Common mode Choke removal from DigiOne Board

Figure -1

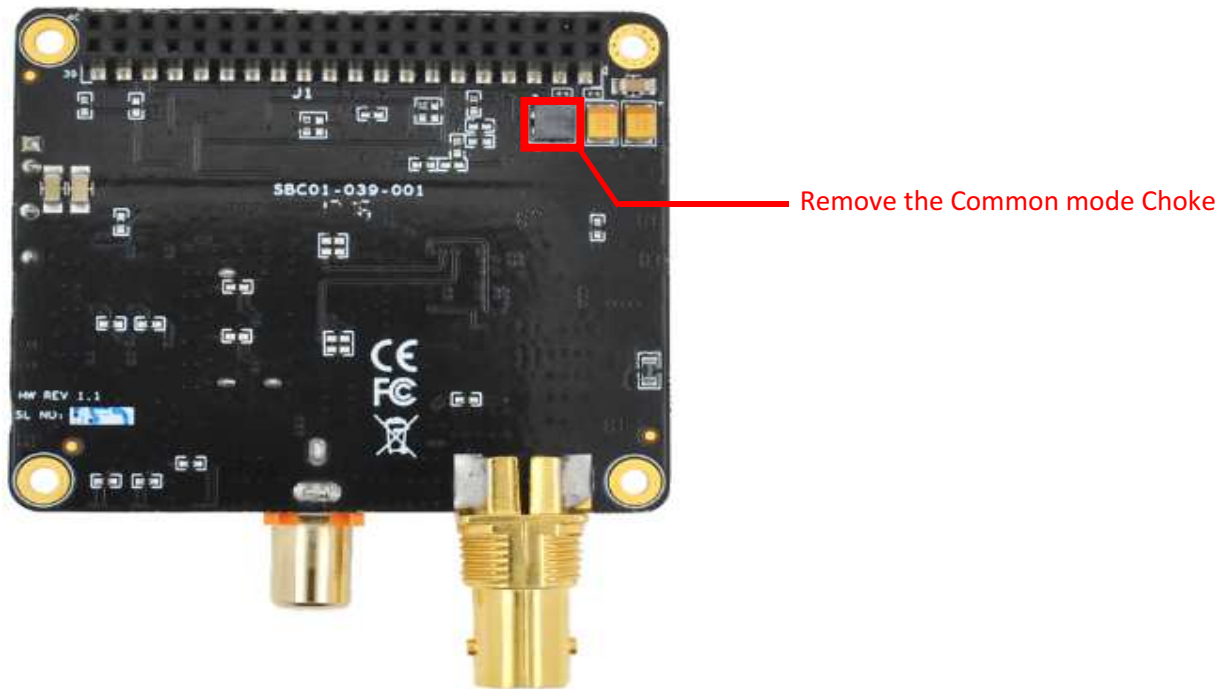
Step 1: Remove the Common mode choke on the bottom side of the PCB (as shown below figure-1)

Figure -2

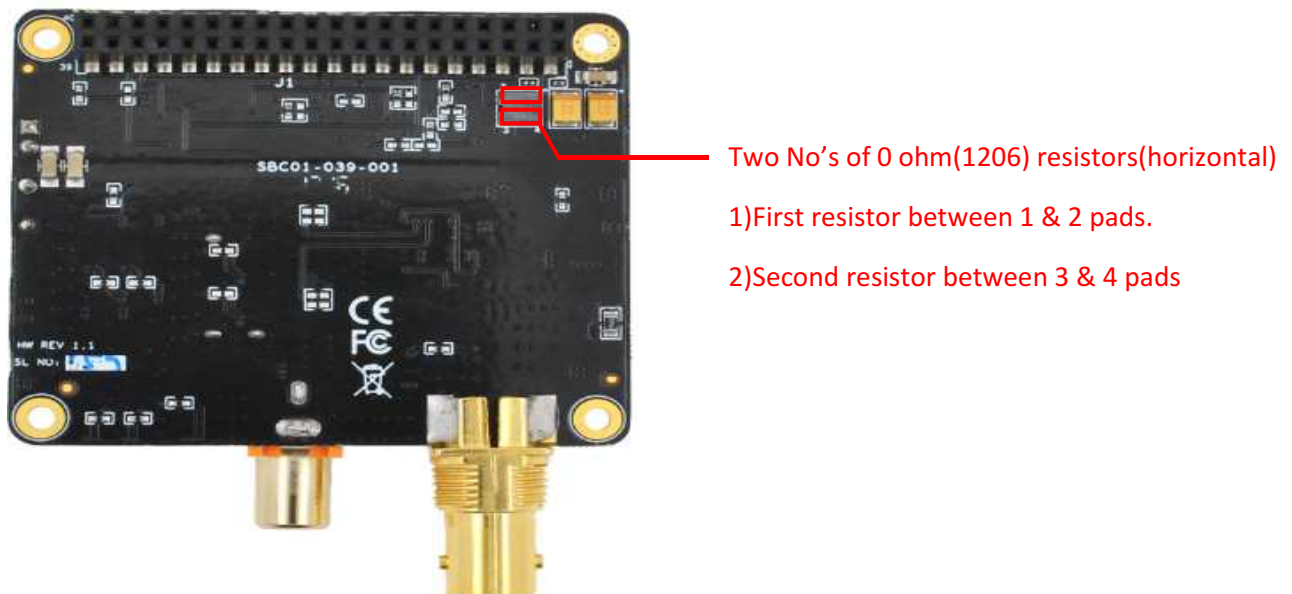
Step 2: Solder the 2 Numbers of 0 OHM resistors (1206 package) horizontally (as shown below figure-2)

Minimum requirement of the resistor is 0 ohm /1206 package/ 0.5W
